Committee of Experts on the Transport of Dangerous Goods and on the Globally Harmonized System of Classification and Labelling of Chemicals

Sub-Committee of Experts on the Transport of Dangerous Goods

Manual of Tests and Criteria, review of Test Series H: determination of self-accelerating decomposition temperature

Transmitted by the Chairman of the Working Group on Explosives*

“Figure 28.4.2.2: Example of determination of SADT or SAPT

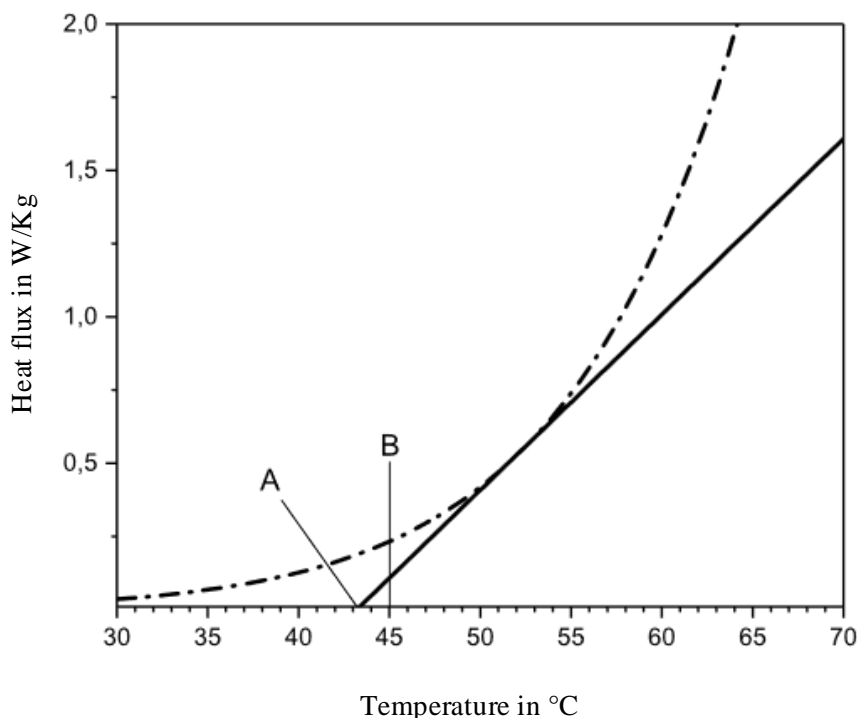
Figure 28.4.2.2 Replace with the following:

— · — ·	Heat generation curve	—	Heat loss curve $L = 0.06 \text{ W (Kg K)}$
(A)	Critical ambient temperature (intercept of heat loss with the abscissa)	(B)	SADT or SAPT (Critical ambient temperature rounded up to next higher multiple of 5°C)

“Figure 28.4.3.1: Measuring period as a function of maximum heat generation measured

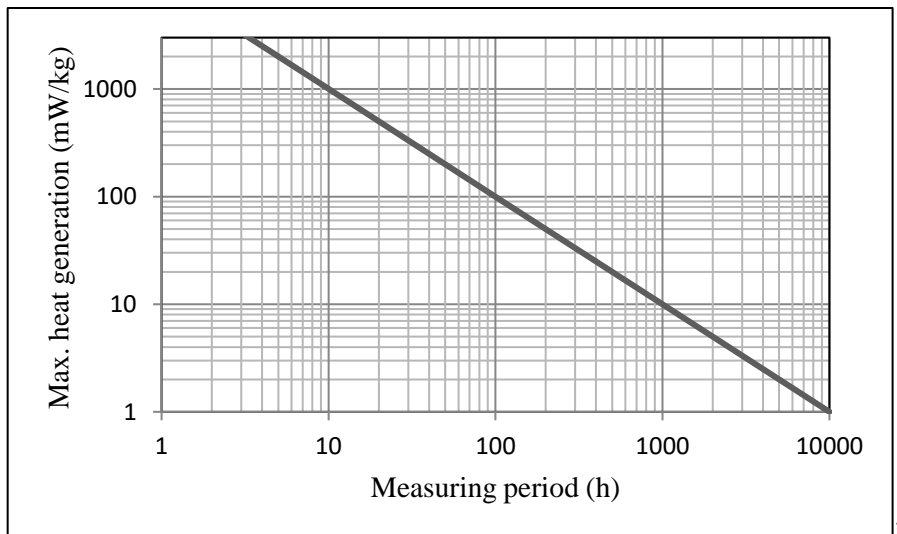
- (c) Start monitoring the rate of heat production. The duration of each test depends on the test temperature and on the rate of heat production. The measuring time as given in Figure 28.4.3.1 can be used as guidance unless it leads to unrealistic measuring times (e.g. greater than 1000 hours). These measuring times are given to achieve a certain degree of conversion of the substance in order to take auto-catalytic effects into account;³

Figure 28.4.3.1 Insert the following new figure:

“Figure 28.4.3.2: Example of determination of SADT or SAPT

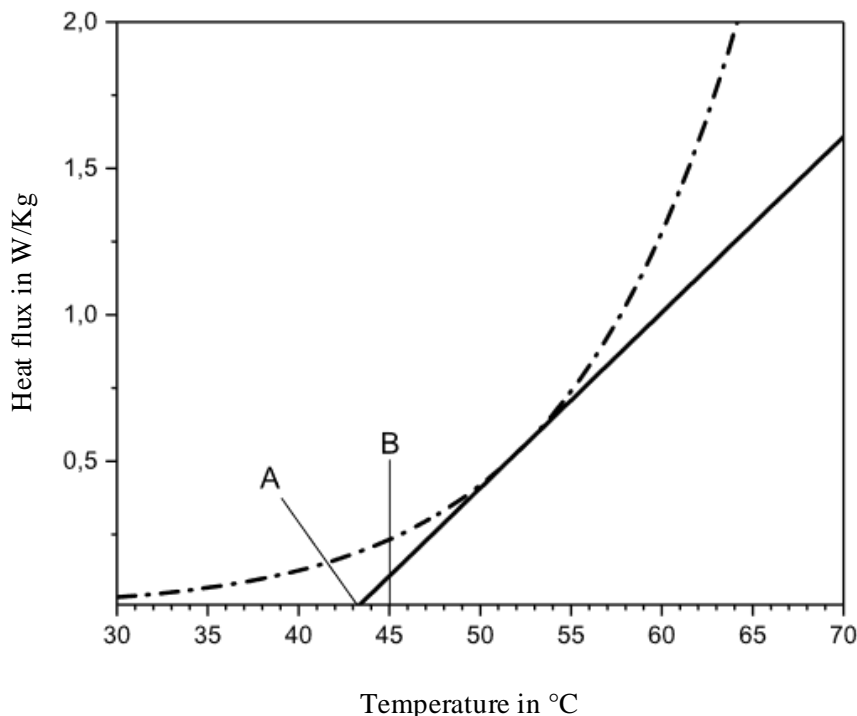
Current figures 28.4.3.1 and 28.4.3.2 Delete.

Insert the following new figure 28.4.3.2:

— · — ·	Heat generation curve	————	Heat loss curve $L = 0.06 \text{ W (Kg K)}$
(A)	Critical ambient temperature (intercept of heat loss with the abscissa)	(B)	SADT or SAPT (Critical ambient temperature rounded up to next higher multiple of 5°C)
